**STRUCTURE: 000 000 72X79 3BDR 2.5BATH SFD W DECK CRAWL**
FLOOD ZONE . . . . : FLOOD ZONE X
# BEDROOMS . . . . . : 3.00 PROPOSED USE . . . . . : SFD
SEPTIC - EXISTING? . . . . : NEW TANK WATER SUPPLY . . . . . : NEW WELL

PROJECT: CAULDER RESIDENCE
HARNETTT COUNTY, NC
BRACED WALL LINE LAYOUT

Re.: Foundation
Plan: Caulder Residence
Project No.: 1201-010360

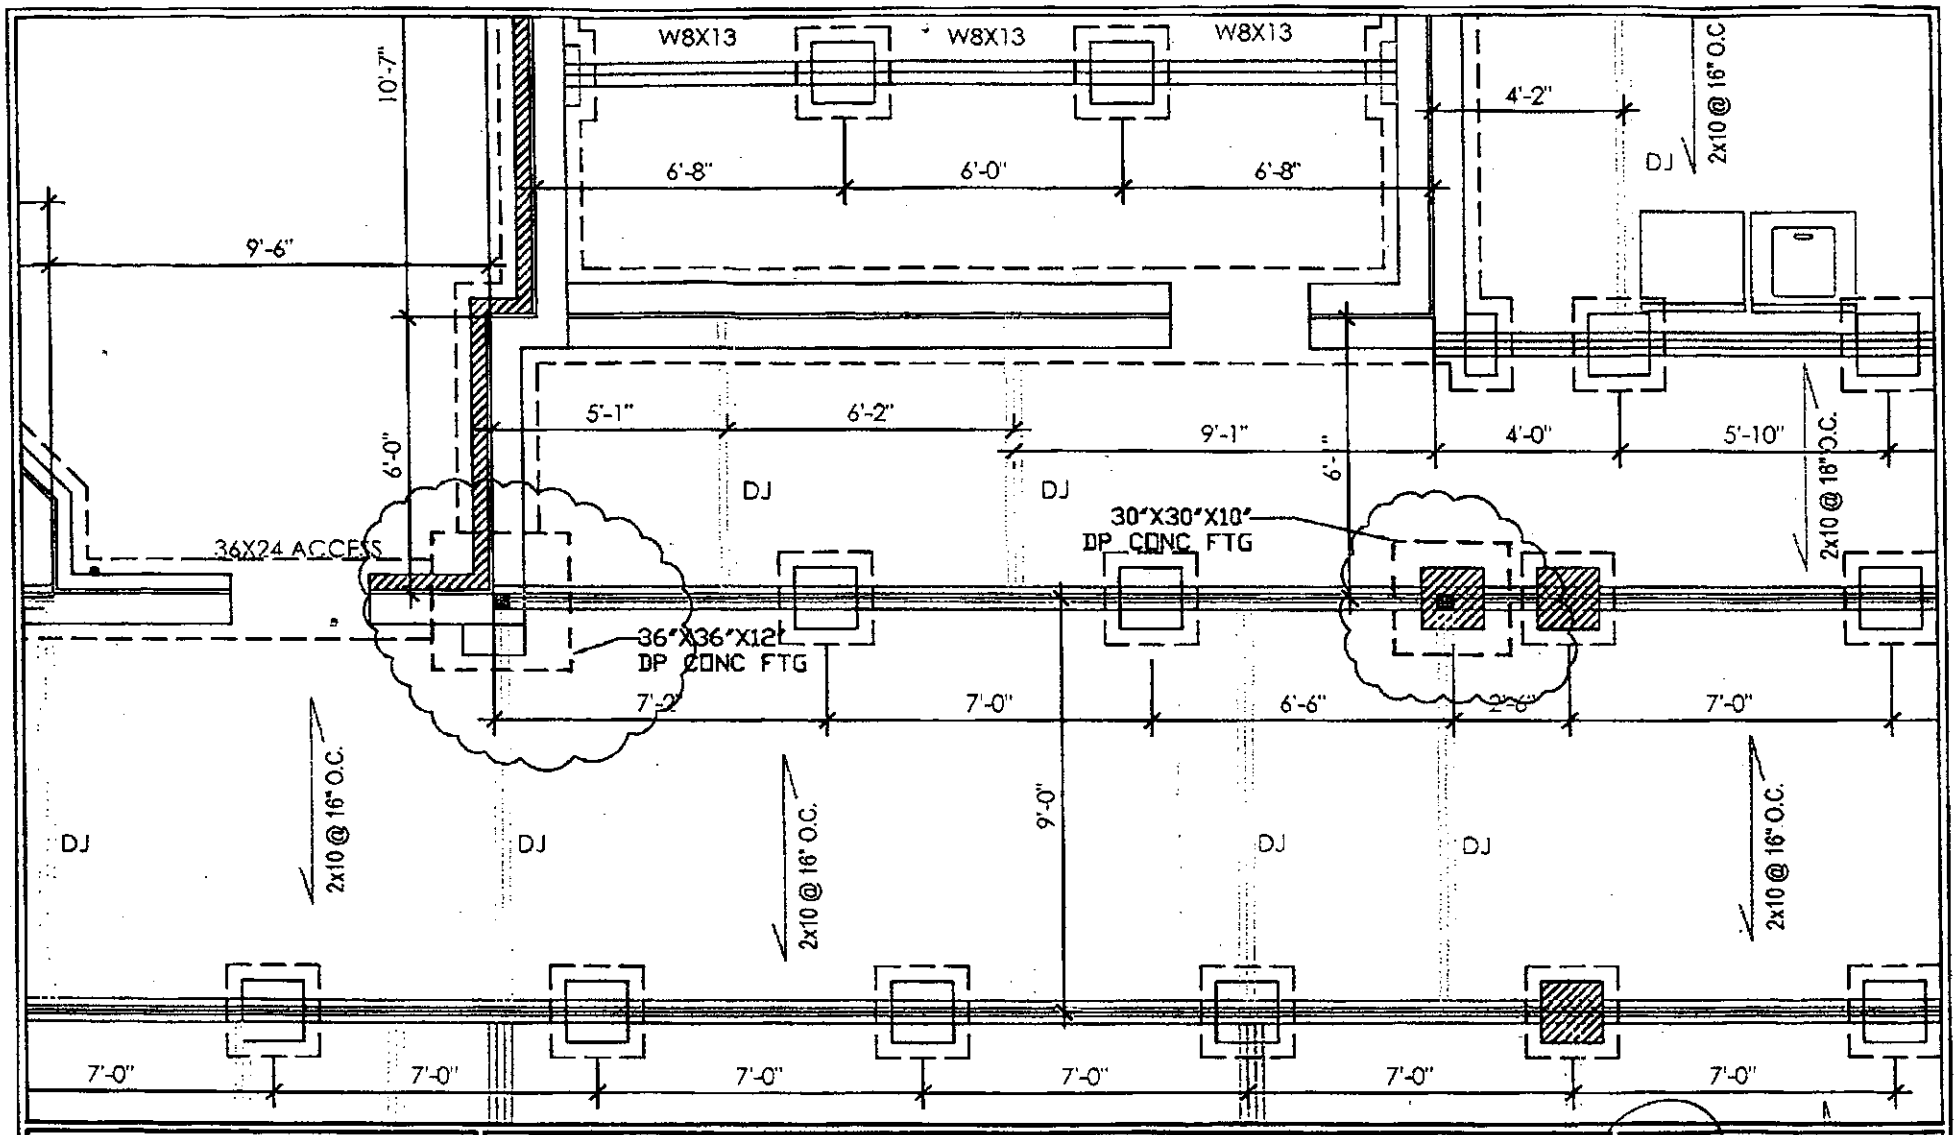
1) Footings under Great Room Beam plan

1) Based on our supplemental plan review and analysis, the W8x67 beam above the Great Room shall be supported by a 30"x30"x10" deep concrete footing on the right side and a 36"x36"x12" deep concrete footing on the left side. The reader is referred to the attached sheet.
